Access Compliance Report

Public Rights-of-Way

Intersection ID: 2813	Main Street: RIDGEFIELD_DR	Cross Street: SWANSTON_DR	Location: SW
ADA ID: CABD546B6021	Ramp Type: PerpDiag	Initial Pass/Fail: Fail	Overall Compliance: No
		Severity Score: 10

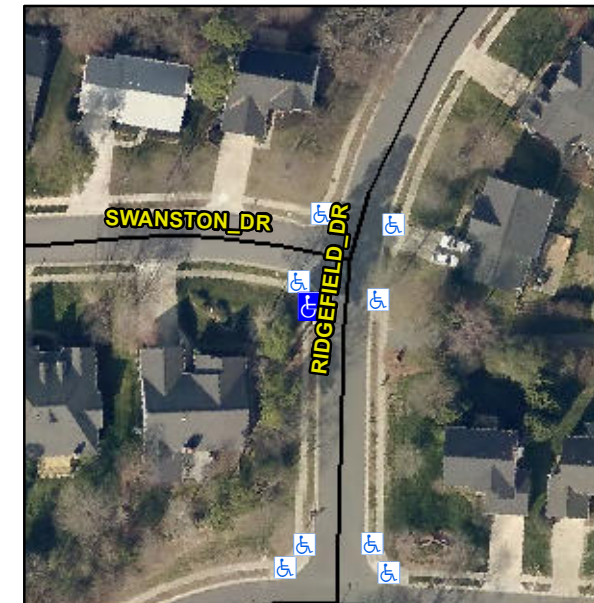
R304.5.1, R304.5.3

Compliance	Description	Data	Compliance	Description	Data
N/A	Ramp Length (in)	49.5	Yes	Ramp Slope (%)	7.1
No	Ramp Width (in)	38.0	No	Ramp XSlope (%)	2.6
N/A	Flare Type LT	N/A	N/A	Flare Type RT	N/A
N/A	Flare Slope LT (%)	N/A	N/A	Flare Slope RT (%)	N/A
N/A	Flare Traversable LT?	N/A	N/A	Flare Traversable RT?	N/A
N/A	Landing Length (in)	N/A	N/A	DWS Provided?	N/A
N/A	Landing Width (in)	N/A	N/A	DWS Contrast?	N/A
N/A	Landing Slope (%)	N/A	N/A	DWS Length (in)	N/A
N/A	Landing X Slope (%)	N/A	N/A	DWS Full Width?	N/A
N/A	Landing Curb? (Y/N)	N/A	N/A	DWS Offset (in)	N/A
N/A	Shared Landing?	N/A			
N/A	Gutter Ponding?	N/A	N/A	Gutter Slope (%)	N/A
N/A	Gutter Lip Ht (in)	N/A	N/A	Gutter X Slope (%)	N/A
N/A	Painted X Walk1?	No	N/A	Painted X Walk2?	No
	X Walk 1 Direction	To E		X Walk 2 Direction	To N
N/A	X Walk 1 Width (in)	N/A	N/A	X Walk 2 Width (in)	N/A
	X Walk 1 Slope (%)	4.8		X Walk 2 Slope (%)	N/A
	X Walk 1 X Slope (%)	1.8		X Walk 2 X Slope (%)	N/A

Remove & Replace Curb Ramp With Two New Directional Ramps or Equivalent.
